PLANS AND DOCUMENTS
referred to in the PDA APPROVAL

Project Description	
PROP. NEW CONTROL BLDG & SITE ALTERATIONS TO EXIST. SERVICE STATION ABBOTSFORD ROAD, BOWEN HILLS	
Scale @A1 1 : 200	Date JAN - 2015
Drawn SS	Approved By GN

AMENDED IN RED

Project Description		Drawing Title	
PROP. NEW CONTROL BLDG & SITE ALTERATIONS TO EXIST. SERVICE STATION ABBOTSFORD ROAD, BOWEN HILLS		SITE PERSPECTIVES	
Scale @A1	Date JAN - 2015	Job Number - Drawing Number	Revision
Drawn SS	Approved By GN	14032 - DA06	A

PERSPECTIVE 1

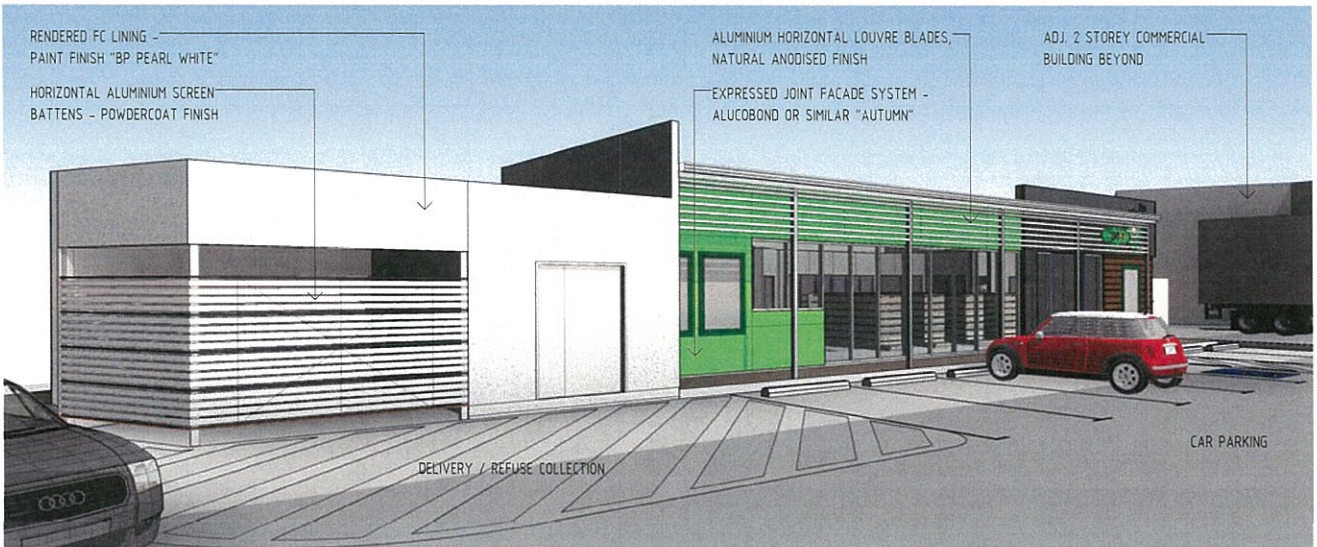
Car park removed and replaced with chevron as per Floor Plan, DA03, Revision C, dated 16/06/2015.
